Subject: Revision 1 to Transnuclear, Inc. (TN) Application for Approval of the TN-LC Transportation Package, Response to Request for Supplemental Information (Docket No. 71-9358; TAC No. L24543)

**Responses to Request for Supplemental Information
(Non-proprietary Version)**

DOCKET NO. 71-9358REQUEST FOR SUPPLEMENTAL INFORMATION (RSI) FOR THE
MODEL NO. TN-LC PACKAGE

*Figure 6.10.2-6
Partially Filled Cavity*

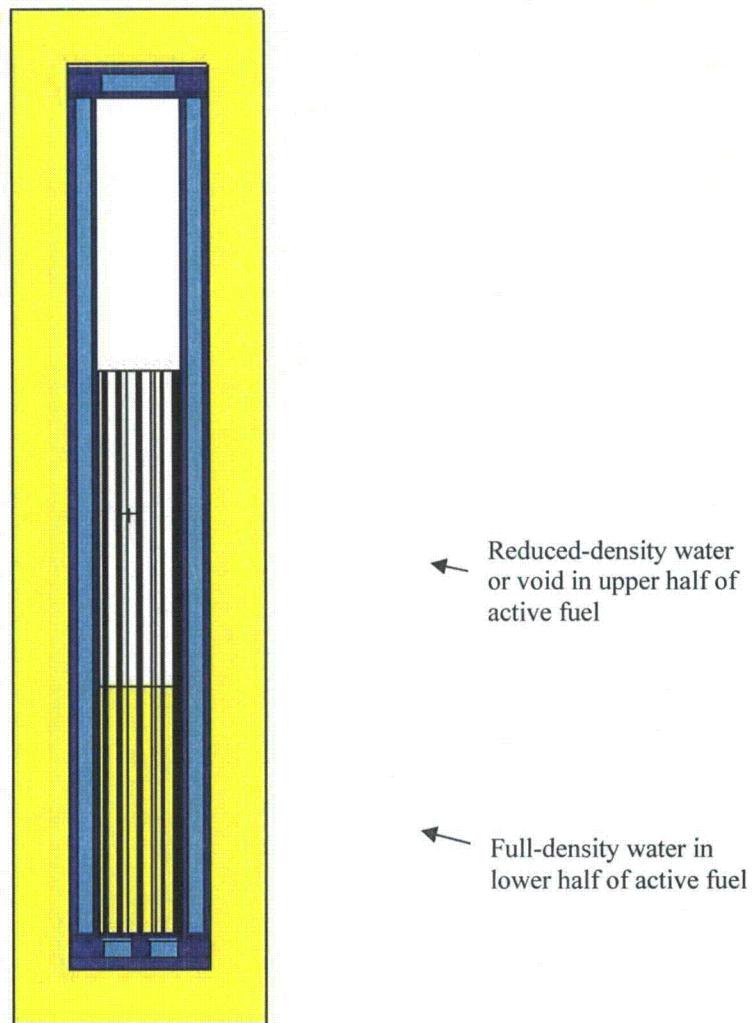
RSI 12 Clarify whether partial and/or preferential flooding has been addressed for each of the four TN-LC basket designs (TN-LC-NRUX, TN-LC-MTR, TN-LC-TRIGA, and TN-LC-1FA). Demonstrate that partial and preferential flooding is less reactive than modeling flooding in all areas of the package at the most reactive density.

basket, and no preferential draining scenarios are considered. Therefore, water is always modeled at the same density in all basket regions of the model.” Clarify that this statement applies to the other TN-LC basket designs.

The TN-LC cavity and all baskets have been designed to drain freely. Therefore, preferential flooding that could result in a more reactive configuration is not credible for any of the baskets. However, the cavity could be partially flooded. Because the baskets drain freely, if the TN-LC cavity is partially flooded, the only credible scenario is that some fuel would be submerged in water, and the remaining fuel would remain unsubmerged. Therefore, any partial flooding scenarios would result in unmoderated fuel. All fuels transported in the TN-LC, including the HEU fuels, show lower reactivity in the absence of moderation. Therefore, any partial flooding would uncover fuel and decrease the reactivity. This effect is demonstrated explicitly for NRU fuel in Appendix 6.10.2 of the SAR.

A discussion on partial and/or preferential flooding is added to the criticality analysis for each of the four basket/fuel types – Appendix 6.10.1, Section 6.10.1.3.1 for TN-LC-MTR basket, Appendix 6.10.2, Section 6.10.2.2.1 for TN-LC-NRUX basket, Appendix 6.10.3, Section 6.10.3.3.1 for TN-LC-TRIGA basket, and Appendix 6.10.4, Section 6.10.4.3.1 for TN-LC-1FA basket.

*Figure 6.10.4-16
KENO Model of the Most Reactive Case with Poison Plate Bolt Holes*

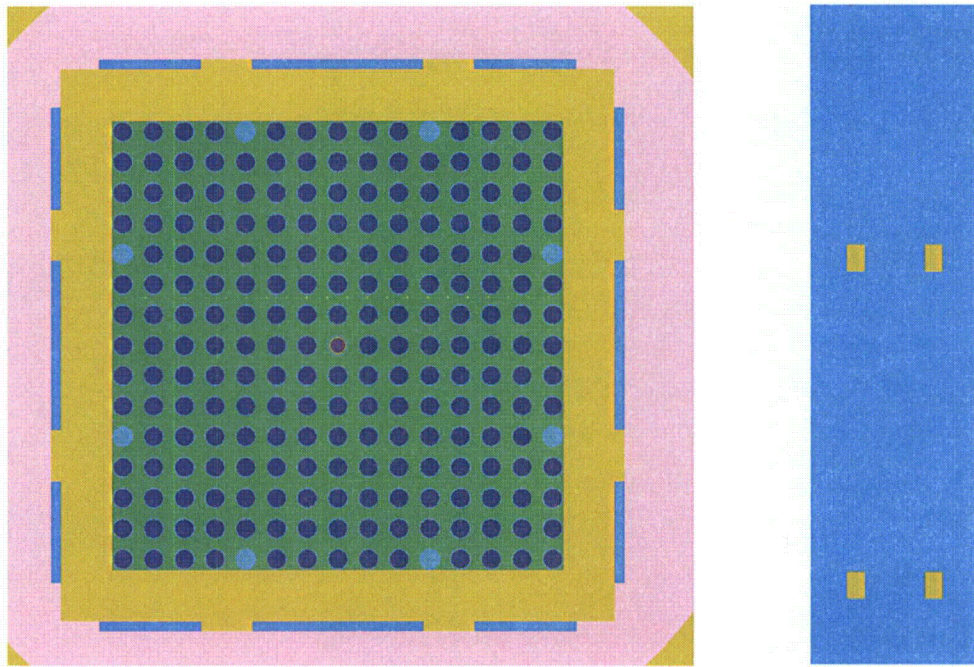
Note 12 on Sheet 1 of Licensing Drawing 65200-71-90 states that the poison plates can be made of multiple pieces of material.

Note 12 on Sheet 1 of Licensing Drawing 65200-71-90 statement is modified to "Each plate (Item 4) may consist of multiple segments in the longitudinal direction. Each segment must be attached by minimum of two studs (Item 3)."
